Entergy Nuclear Operations, Inc.  
Palisades Nuclear Plant  
27780 Blue Star Memorial Highway  
Covert, MI 49043

Palisades Nuclear Plant  
Docket 50-255  
License No. DPR-20

License Amendment Request: Emergency Core Cooling System Surveillance Requirement

SCHEMATIC OF CONTAINMENT  
SUMP ENTRANCE PATHWAYS  
(NOT TO SCALE)

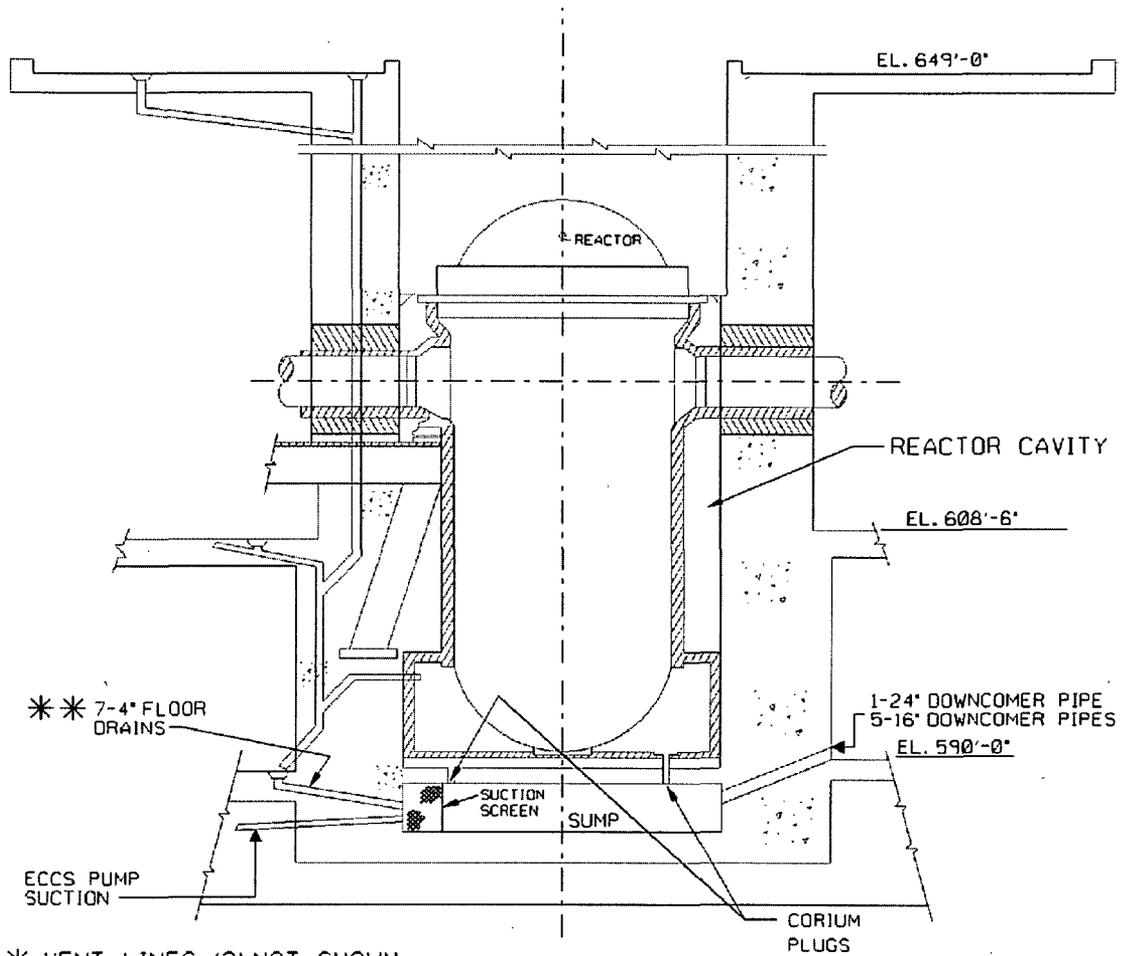
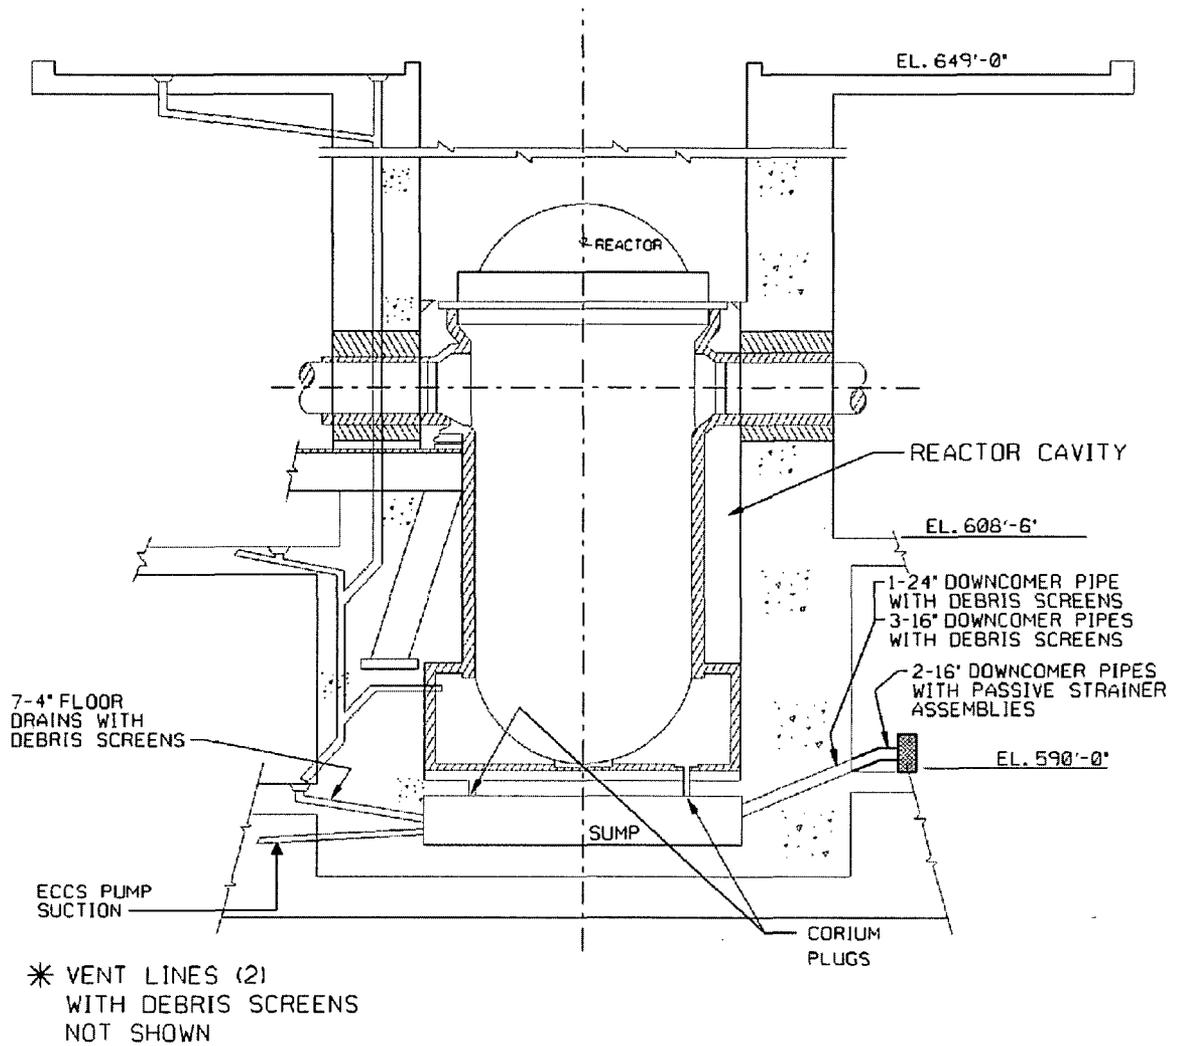
The containment sump exit pathways consist of two suction pipes that provide flow paths to the ECCS pumps. The ECCS pumps consist of low pressure safety injection (LPSI), high pressure safety injection (HPSI), and containment spray system (CSS). The LPSI pumps are not used during post-LOCA recirculation. Following an accident, during the recirculation mode of emergency core cooling, the sump provides a suction source of water to the ECCS and CSS pumps which provides adequate net positive suction head (NPSH) to the pumps. The ECCS suction inlet screens, located in the sump, protect the systems from debris entrainment during recirculation from the sump. Attachment 1 provides a figure that schematically reflects the containment sump entrance and exit pathways.

ENO's planned modification removes the existing ECCS suction inlet screens. In lieu of the ECCS suction inlet screens, ENO is planning to install passive strainer assemblies on the 590 foot elevation of containment. The passive strainer assemblies would connect to the containment sump via two containment sump downcomer pipes. These two containment sump downcomer pipes would provide the post-LOCA credited flow pathway from the passive strainer

assemblies to the containment sump to provide a suction source of water to the ECCS and CSS pumps. Attachment 2 provides a figure that schematically reflects the containment sump entrance pathways after the planned modification.

In addition to the passive strainer assemblies, debris screens are to be installed on the remaining open containment sump entrance pathways, which include the four remaining downcomer pipes, the seven containment floor drains, and the two containment sump vent lines. The debris screens are intended to intercept and segregate debris outside of the containment sump envelope. The reactor cavity corium plugs, located in the reactor cavity drain lines, contain pellets within the corium plug tube, tube end cap, and tube bottom cup support assembly which form a debris interceptor similar to the debris screens. These containment sump entrance pathways do not provide a credited post-LOCA flow path into the containment sump envelope. PNP housekeeping standards would be used to ensure that these containment sump entrance pathways are not restricted by debris. The proposed SR includes a requirement to ensure that these containment sump entrance pathways show no evidence of structural distress or abnormal corrosion. Including this requirement in the surveillance provides assurance that there are no barrier breaches that would allow debris to enter the containment sump and cause downstream equipment damage.

The proposed change modifies TS SR 3.5.2.9 to require verification, by visual inspection, that the containment sump passive strainer assemblies are not restricted by debris, and the containment sump passive strainer assemblies and other containment sump entrance pathways show no evidence of structural distress or abnormal corrosion.
